Re: **Pangea's Comments on Dual Phase Extraction Pilot Test Report**
1230 14th Street, Oakland, California
ACEH Case No. 295

Re: **Comments on Dual Phase Extraction Pilot Test Report**
1230 14th Street, Oakland, California
ACEH Case No. 295

Former Shell Service Station
 1230 14th Street
 Oakland, California

Figure
2

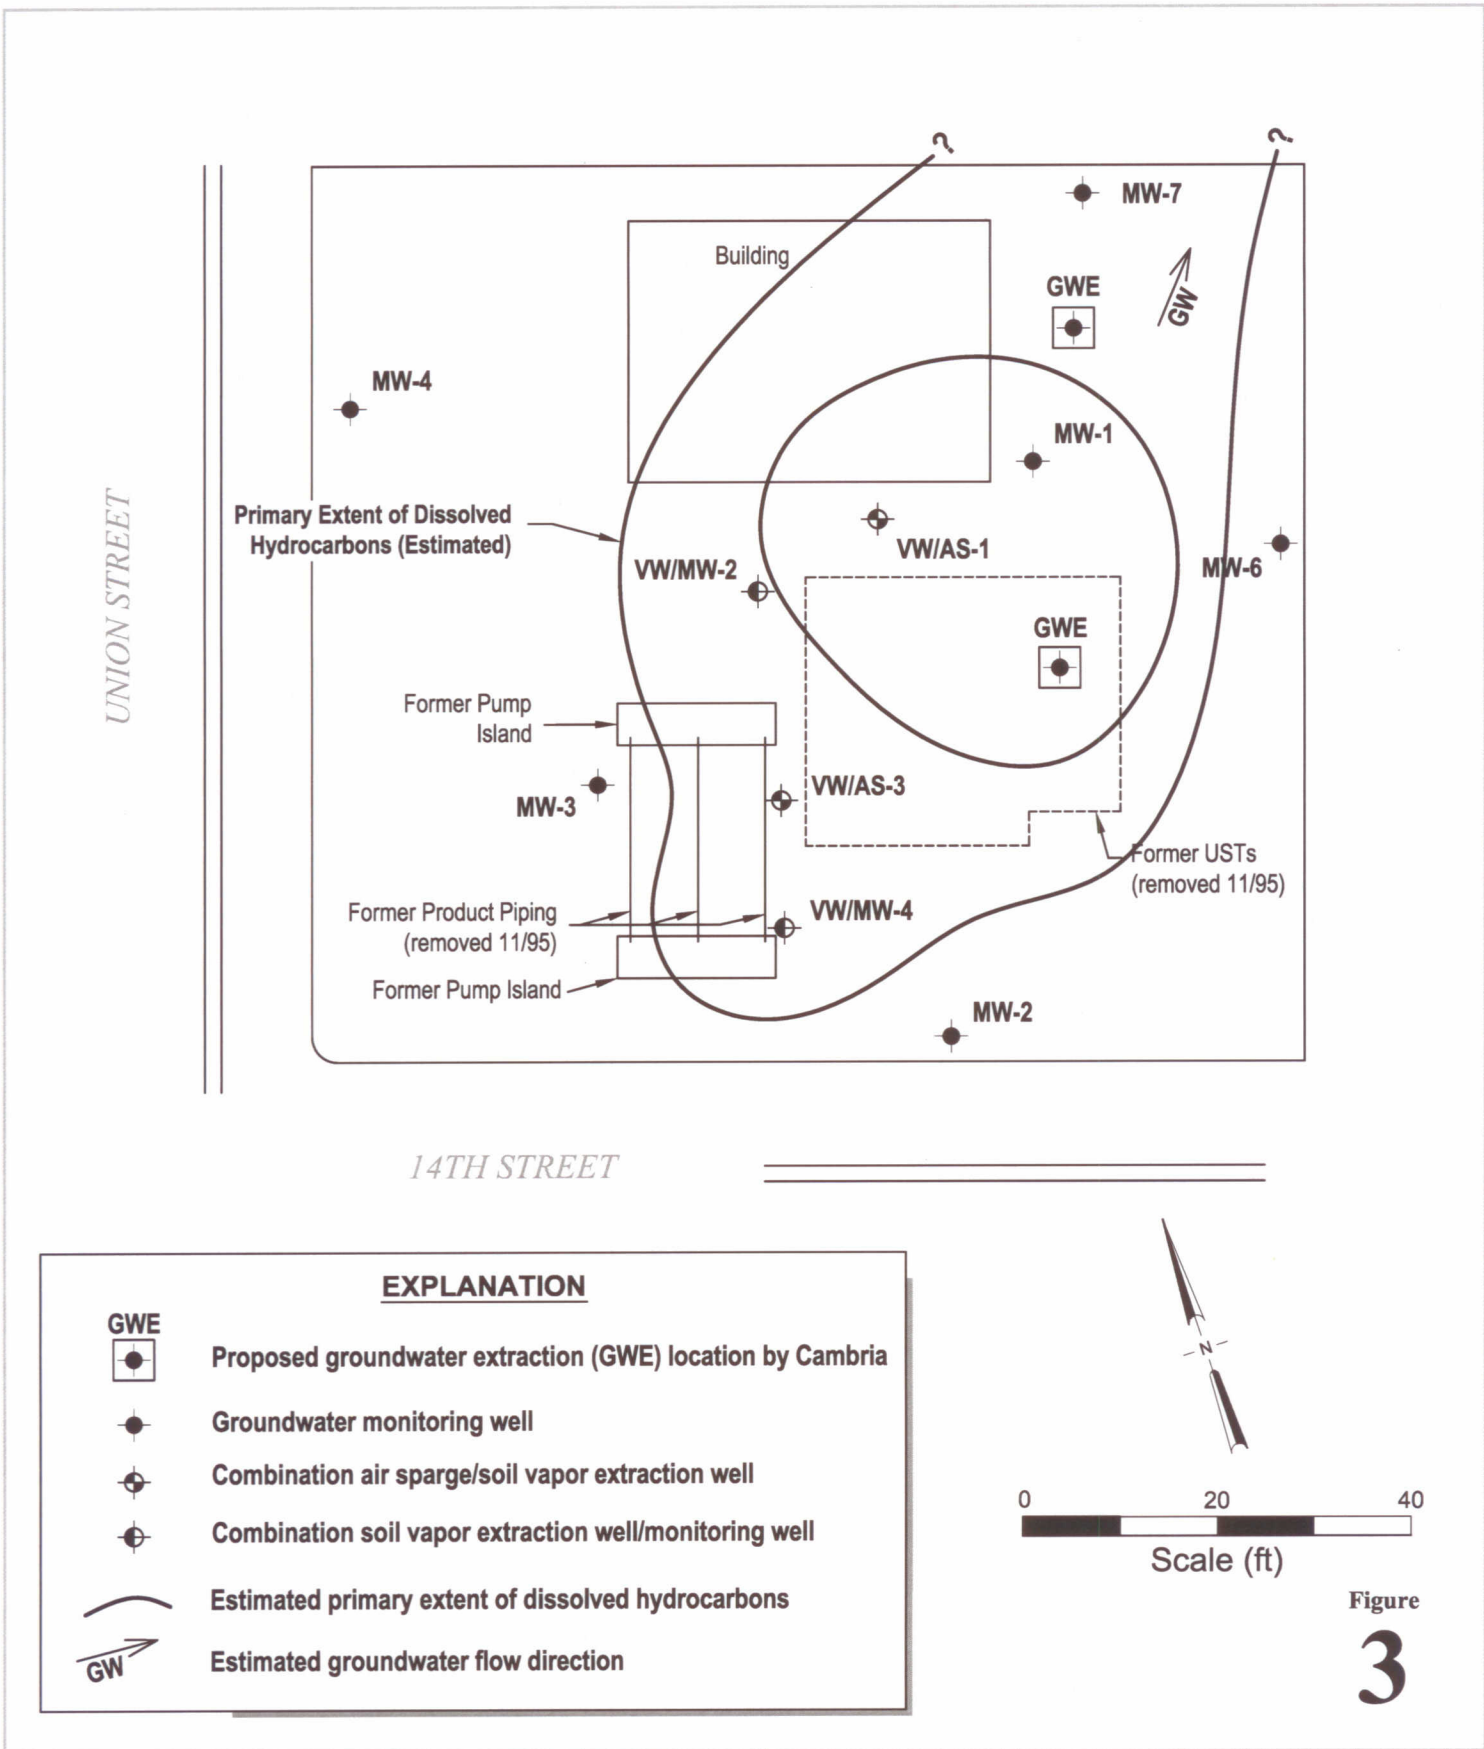
Even if GWE was considered an appropriate approach, the proposed GWE well network of two wells does not adequately address contamination northwest and southwest of the former UST area. At least two additional extraction wells would be required to adequately influence the impacted area. Figure 3 illustrates that the two groundwater extraction (GWE) locations proposed by Cambria would be insufficient to address the primary extent of dissolved hydrocarbons if GWE were deemed an appropriate remedial approach for the site.
